UNITED STATES PATENT AND TRADEMARK OFFICE

| APPLICATION NO. | FILING DATE | FIRST NAMED INVENTOR | ATTORNEY DOCKET NO. | CONFIRMATION NO. |
|----------------------------------------------------------------------------------------|-------------|----------------------|--------------------------------|------------------------|
| 10/594,733 | 04/05/2007 | Hiroshi Shibaoka | 21581-00371-US1 | 5777 |

| Office Action Summary | Application No. | Applicant(s) | |

DETAILED ACTION

FIG. 2

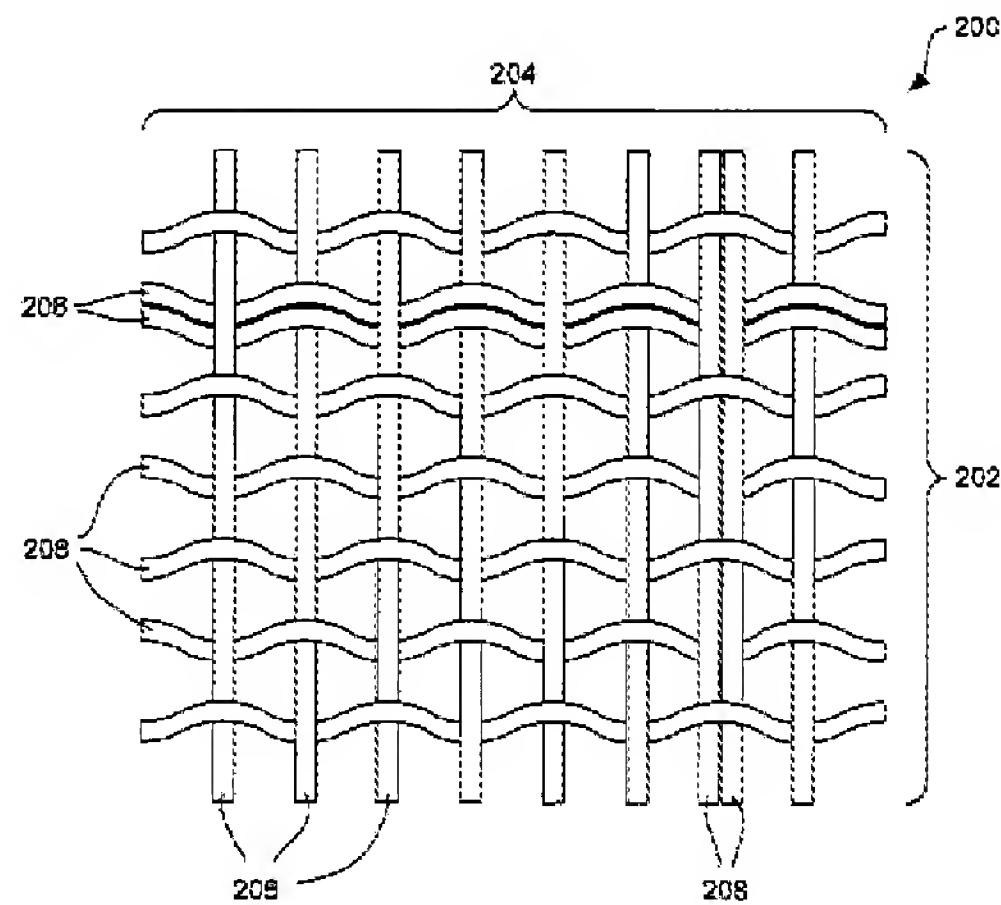
Fukunishi differs from the current application and does not teach a paralleled yarn rip stop yarn which is the equivalent of applicant's B-yarn. Corner teaches blended outer shell fabric for jackets and garments [0001]. Corner teaches woven fabric that are lightweight and employ a rip stop weave [0014]. Corner teaches the rip stop yarns have a construction similar to the body yarns but are provided in pairs that are woven through the fabric as show in Corner's Fig. 2 below. Corner teaches a paralleled secondary, B yarn.

It would have been obvious to one of ordinary skill in the art at the time the invention was made to employ a rip stop woven fabric with a rip stop yarn that is a paralleled yarn motivated to produce a lightweight fabric for outerwear that also has strength provided by the rip stop yarn.
